# TRANSPORT OF WORKS ACT ORDER 1992 THE PROPOSED NETWORK RAIL (EAST WEST RAIL BICESTER TO BEDFORD IMPROVEMENTS) ORDER

**Proof of Evidence in relation to Flood Risk**

**Amy Hensler 156/3/1**

On behalf of **O&H Q6 Limited**

**Figure 5-2 Schematic of method to estimate floodplain width and area**

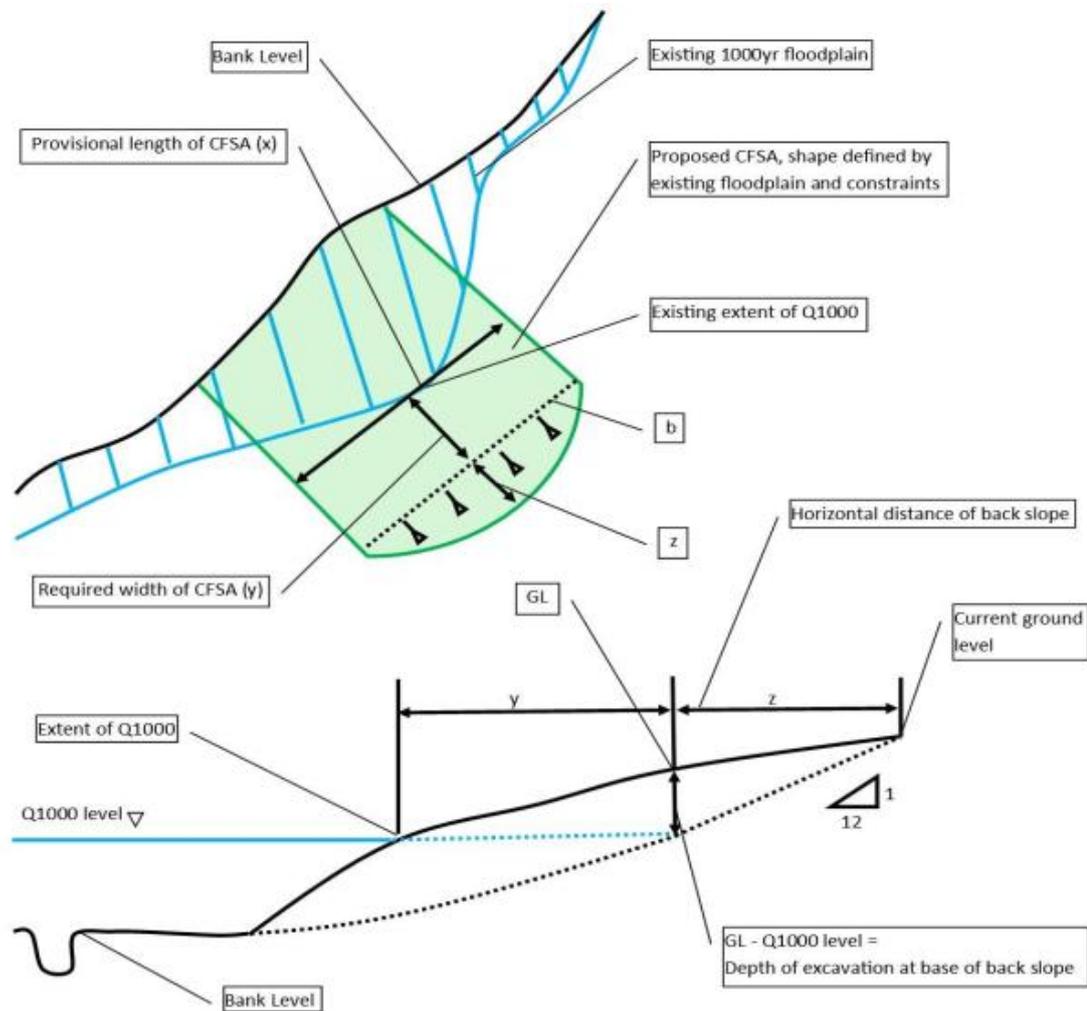
5.1.11 The second set of estimates effectively calculates the approximate 'width' of floodplain storage that might be required based on the provisional length drawn in the CFSA by estimating an area that might be expected to be required based on the estimate of volume lost (described in Paragraph 5.1.5) and a regular-shaped 'wedge' (see Figure 5.2 below). This calculation then concludes with a 'yes/no' statement as to whether that required area fits "inside the drawn area". Where the conclusion is Yes, the area fits "inside the drawn area", there is no evidence that demonstrates that the volumes required across each level band can be provided.

**Figure 5-3 Map of Woodley Crossing, Woburn Sands (2D0023)**

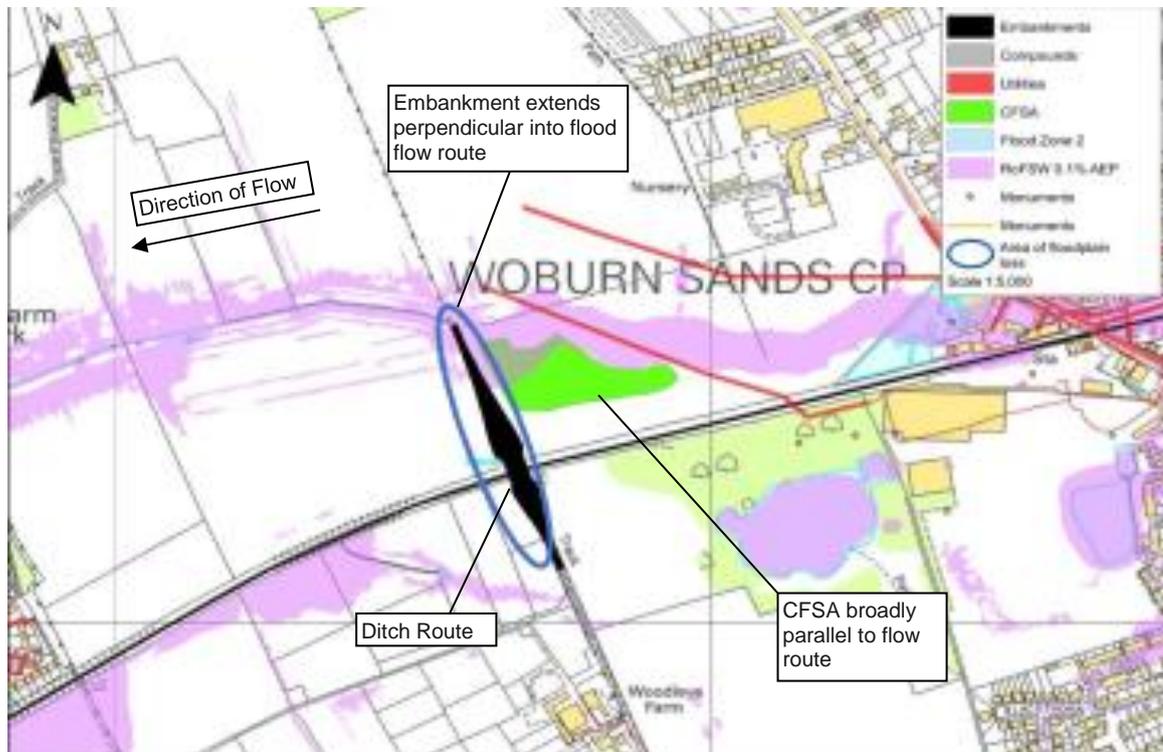
5.1.15 For example, at Woburn Sands, the area of floodplain lost is broadly oriented NNW-SSE and appears to reach into the centre of the existing flow route, as annotated in the figure below, recreated from 2D0023 in Appendix 13.1E. Further, the proposed embankment runs along the route of an existing ditch. The CFSA proposed is irregular, but predominantly oriented E-W and parallel to the direction of flow. Insufficient information has been provided to demonstrate that volume can be provided on a level for level basis for all losses.

6.2.3 For example, at the Woburn Sands Woodley Crossing (see paragraph 4.1.14), the proposed embankment crosses the floodplain, perpendicular to the direction of flow, and as indicated on the map (Figure 5.3 above) there may be a significant restriction to conveyance. This may, regardless of any CFSA proposed, increase flood risk to the O&H land upstream of the embankment. No assessment has been made regarding this.

6.2.4 The FRA makes no mention of the need for a flood relief culvert, or similar measures, in this location which might maintain conveyance, in the proposals or recommendations.
